ILT Send Training Timer

Comment # 269

Xuebo Wang, Hao Ren, Xiang He
Huawei

Figure 178B-8—Training control state diagram

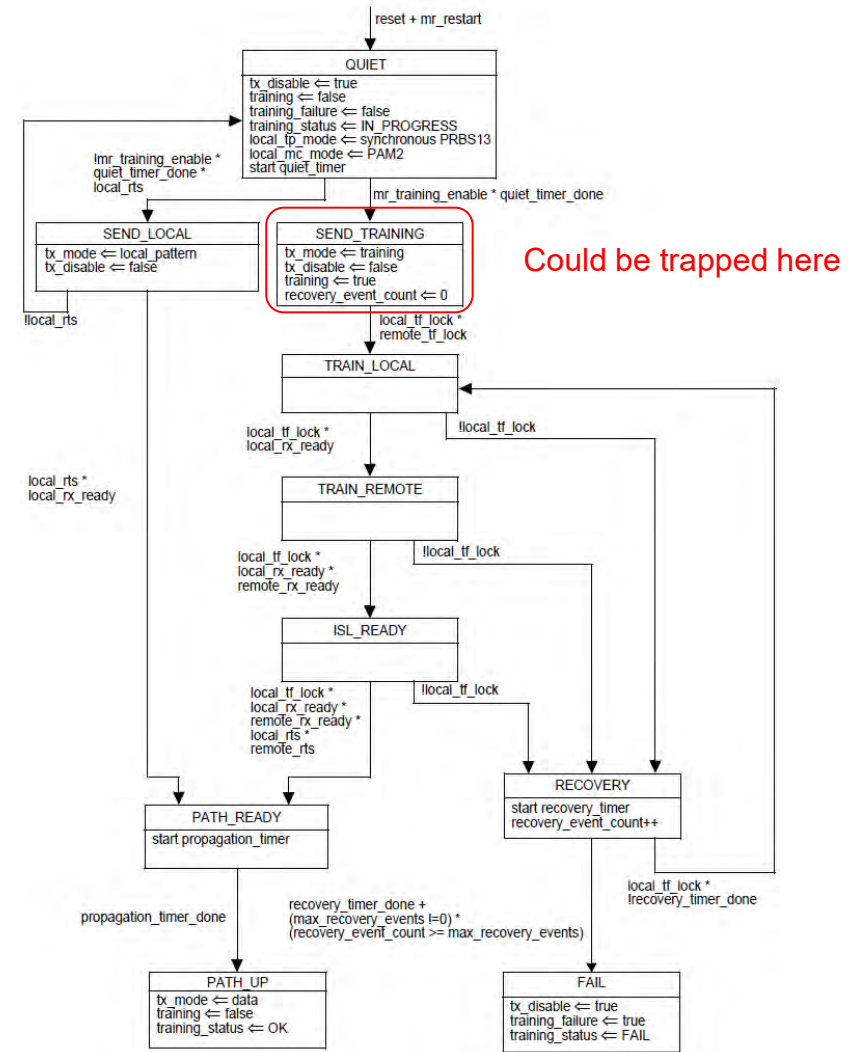
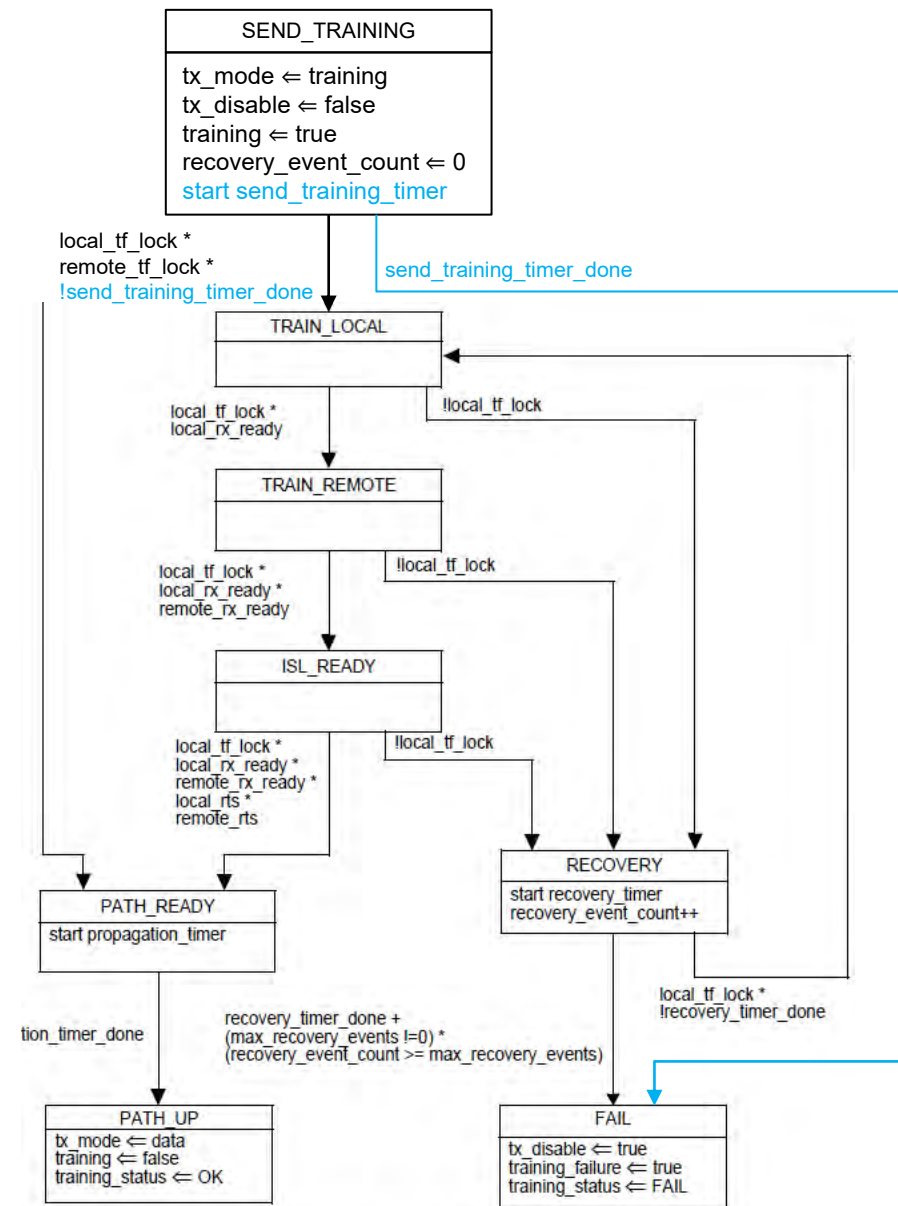
- The training control state diagram defines the operation of ILT for AUI components and PMDs.
- For avoiding unexpectedly long time consumed by ILT, training_timer was proposed to start in TRAIN_LOCAL state in [ran_3dj_02a_2505](#).
- However, a risk of being trapped in SEND_TRAINING state exists if either local_tf_lock or remote_tf_lock is false for long. Need to resolve this!

- To avoid being trapped in the SEND_TRAINING state for long, send_training_timer is proposed to use.

send_training_timer

This timer is started when the training control state diagram on a lane enters the SEND_TRAINING state (see Figure 178B-8). The terminal count of this timer is between 100 ms and 200 ms.
